## County of Loudoun

#### MEMORANDUM

**SUBJECT:** ZMAP 2012-0011 – Tuscarora Crossing  
Second Referral

MODULAR BUILDING FLOOR PLAN/ELEVATION

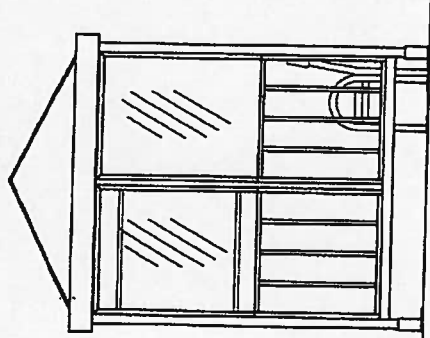
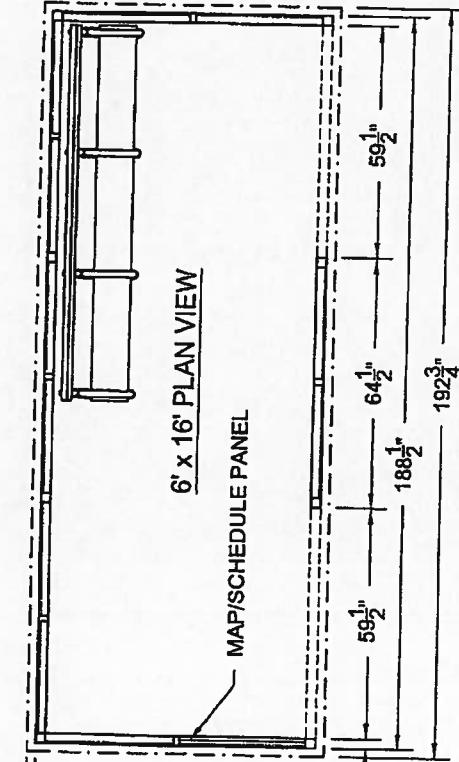
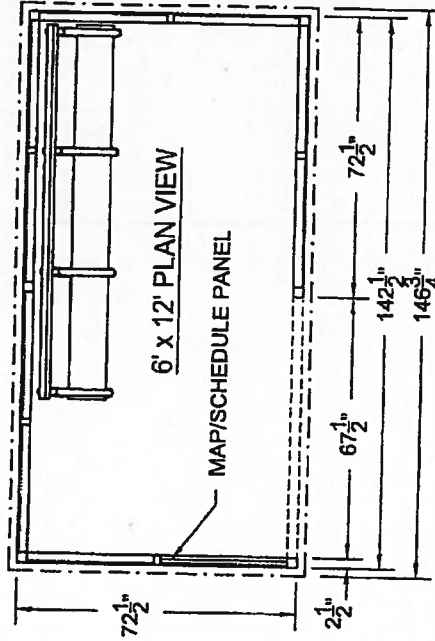
10. TCI recommends that the Applicant proffer to install a bus shelter as per the standards outlined in Chapter 3 of the 2010 CTP. In addition, per the 2010 CTP (*Chapter 3, bus Shelters and Amenities Policies, Policy #4 and #5*), the Applicant should agree to maintain the shelter including lighting and trash removal. This shelter should be consistent with the County's standard (non-proprietary) design (see **Attachment 8**) and will be installed at a future time when public bus route(s) serves this corridor. The final location of the shelter is to be determined in consultation with TCI staff.
